STAFF REPORT

PLANNING DIRECTOR DECISION

FILE NO.: DR-13-06

REQUEST: Class I Design Review for the proposed removal of five parking spaces and relocation of ADA spaces, expansion of patio area, moving of landscaped area, and new roll-up door at Willamette Marketplace, 2070 8th Avenue

SHEET TITLE
NEW SITE PLAN

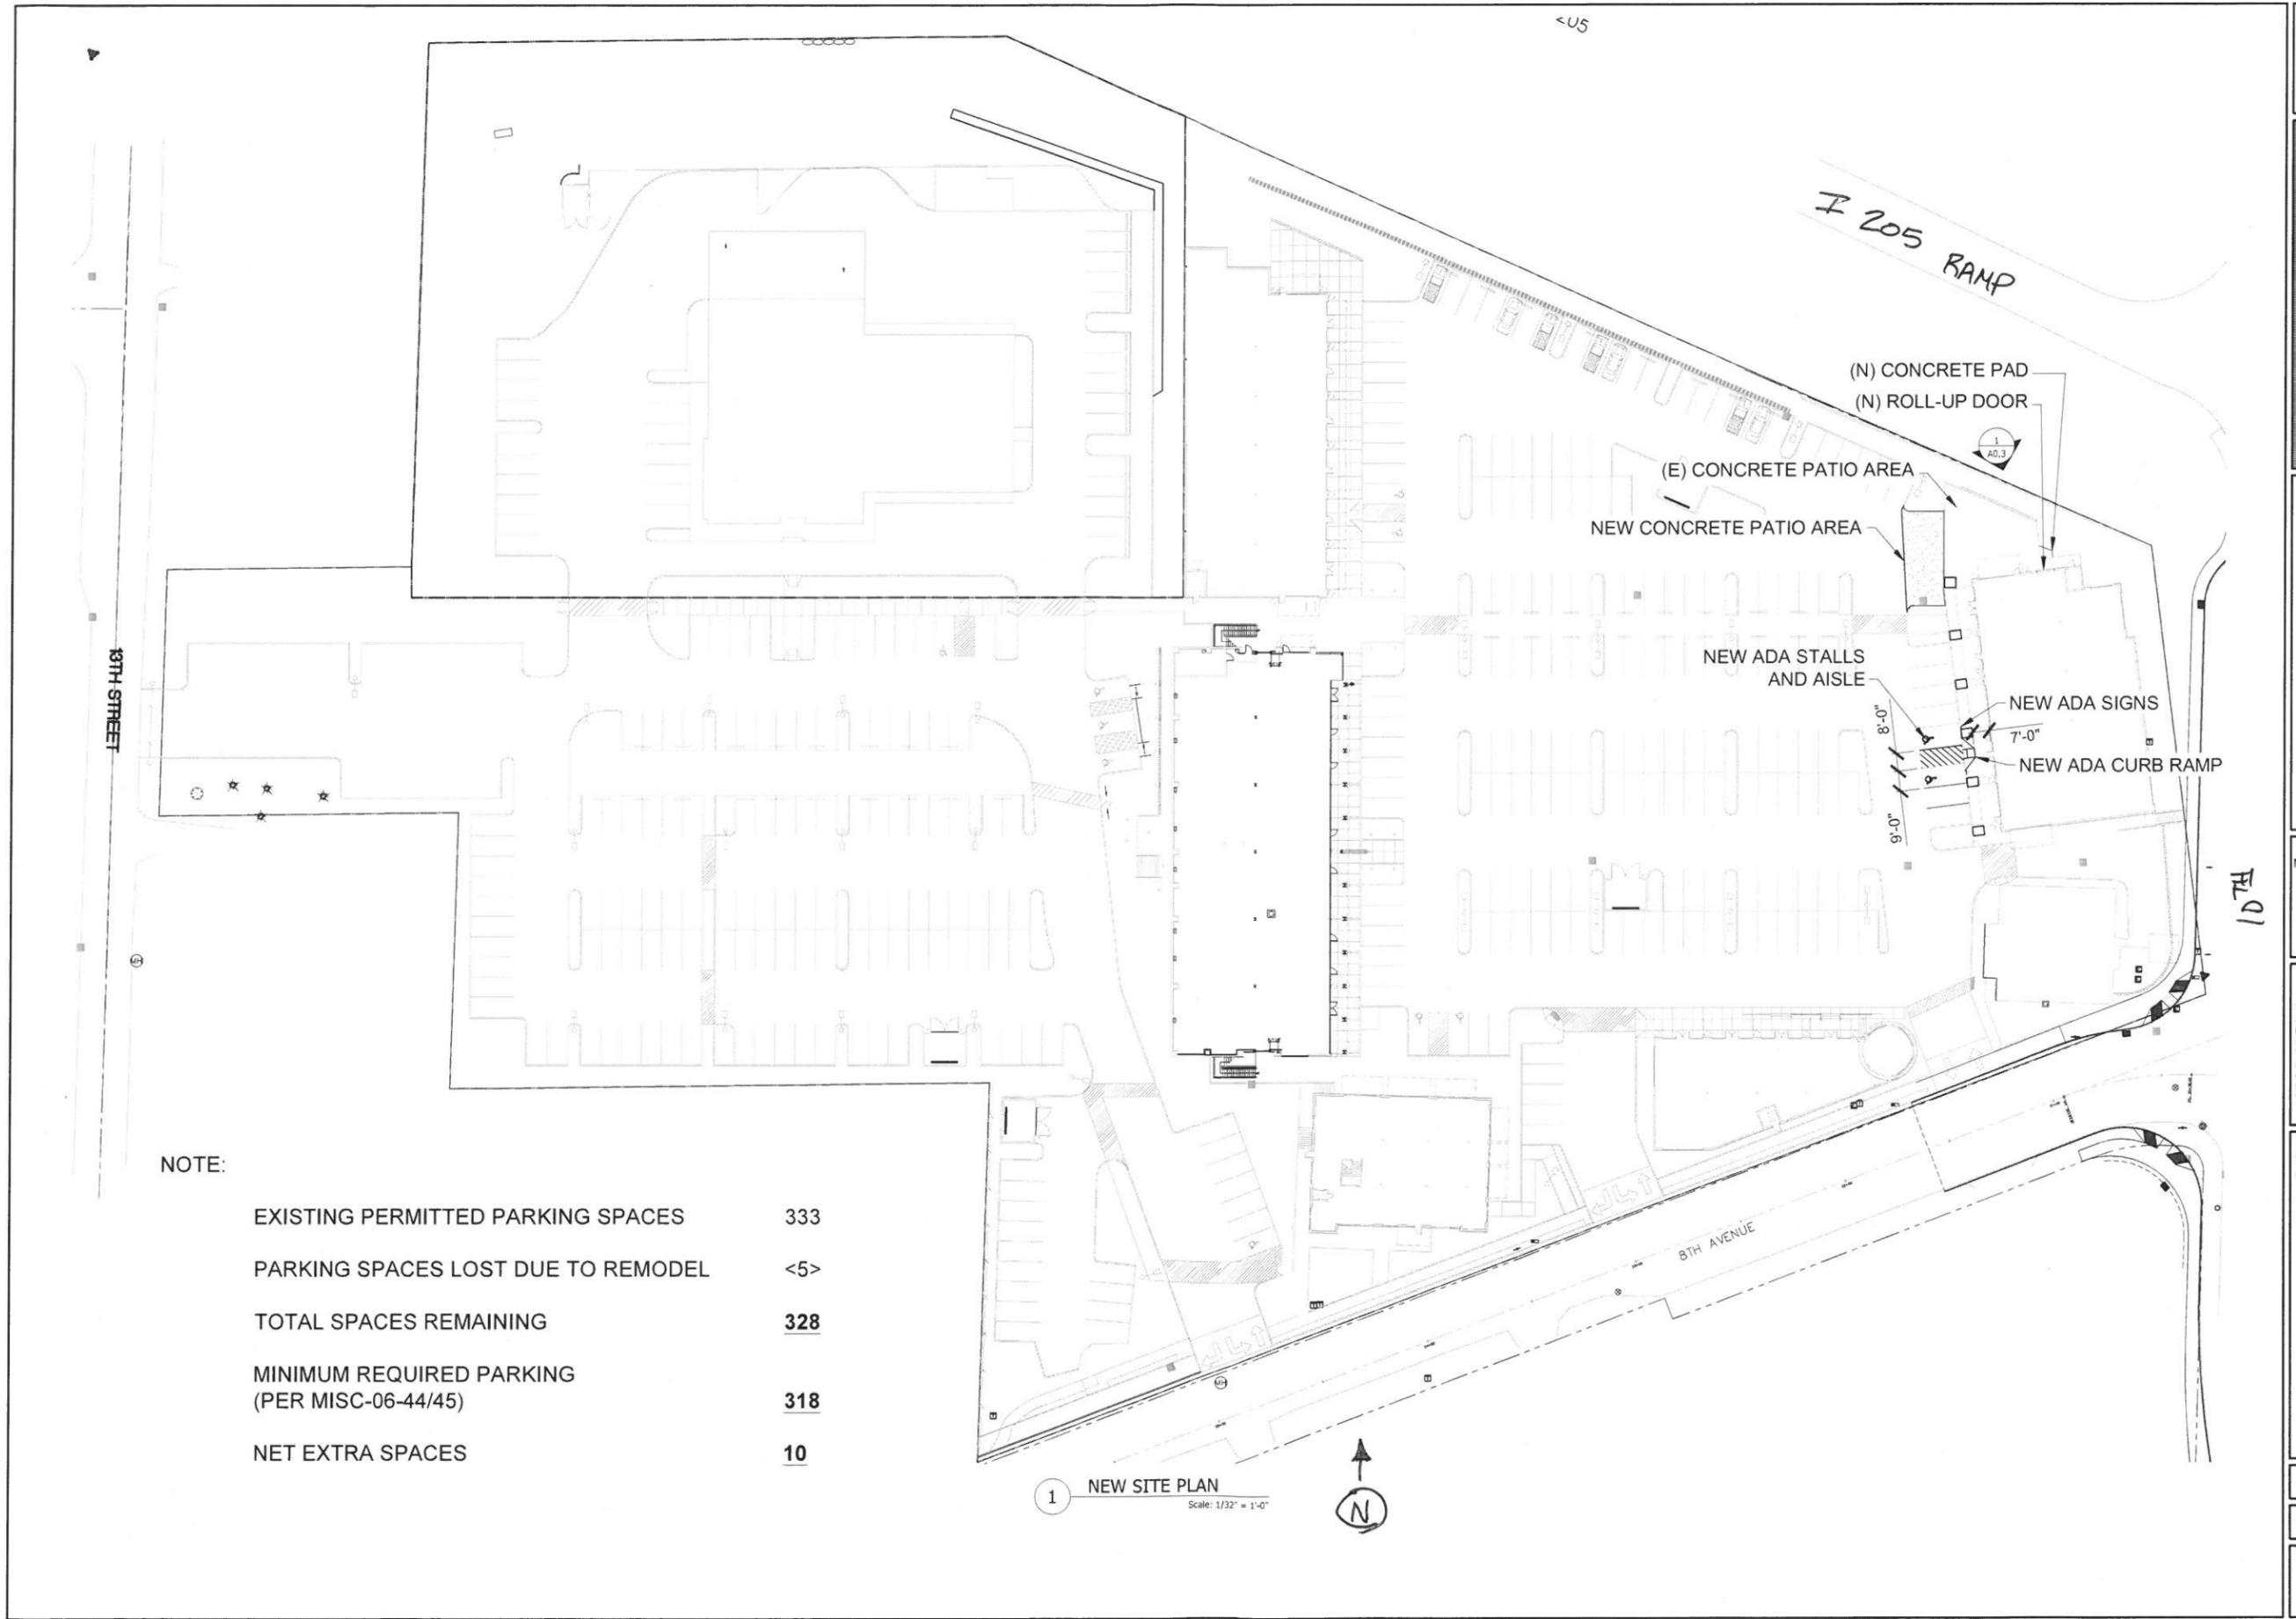
The two ADA spaces proposed will be van-accessible due to the eight-foot-wide aisle between them. Section 46.150(B)(6) requires all van-accessible spaces to be signed as such. Recommended Condition of Approval 2 requires this.

Staff Response 6: The proposed new ADA spaces are nine by 18 feet. They are consistent with subsection B as modified by proposed Condition of Approval 2. See Staff Response 7 below. The criteria are met upon the inclusion of Condition of Approval 2.

Staff Response 7: The two proposed spaces are located next to a ramp, across the sidewalk from a door into the building. They are at least as close to an entrance via an accessible route as the spaces they replace. They are both van-accessible as there is proposed to be an eight-foot-wide area between them, which is connected to the ramp to the sidewalk. Subsection (6) above requires all van-accessible spaces to be signed as such. Proposed Condition of Approval 2 requires this. Staff determines that the criteria are met upon the inclusion of Condition of Approval 2.

2. Disabled Parking Spaces Signage. The two proposed disabled spaces shall have signage stating they are van-accessible.
3. Landscaping Mitigation. The amount of existing landscaping paved north of the proposed roll-up door shall be mitigated for by expanding the landscape strip northward into the proposed new patio area west of the building. Any plants lost shall be replaced by plants of the same species and size in the newly expanded landscape strip, spaced no more than five feet apart from each other or existing plants.
4. New Pavement Area Width. The addition of pavement to existing landscaped areas east of the existing patio shall not be more than 10 feet east-to-west.

1 NEW NORTH ELEVATION

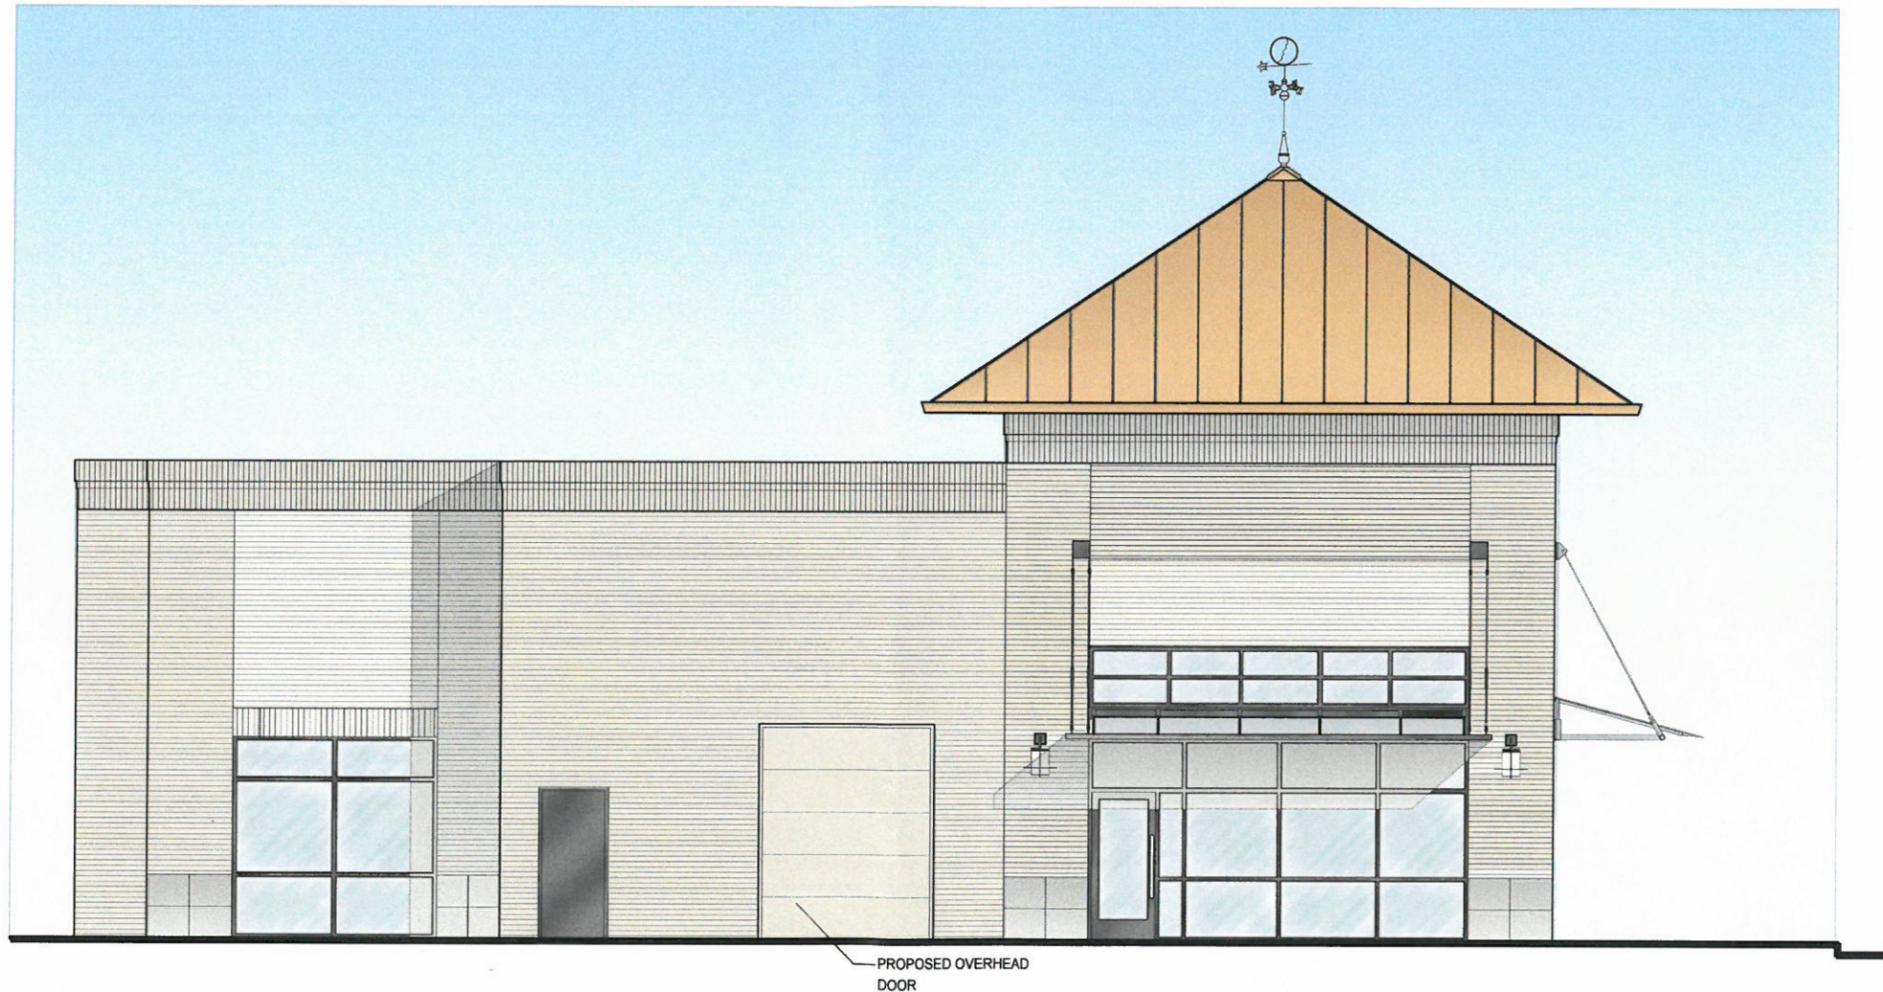
Staff Response 10: The roll-up door will be the same or a very similar shade of color as the building, so it will not be contrasting architecture. It will break up a stretch of wall that is not broken up by windows or doors now. No windows or smaller doors will be eliminated. It is compatible in size with the groupings of windows on the building. Staff finds that the relevant architectural criteria are met.

Staff Response 12: The proposed new door is the only item in the project that could create glare; it will not be unpainted metal but will be the same tan color as the bricks of the building. Therefore it will not create glare. Also, this side of the building is heavily buffered from the highway to the north by existing trees and shrubs. Staff determines the criterion is met.
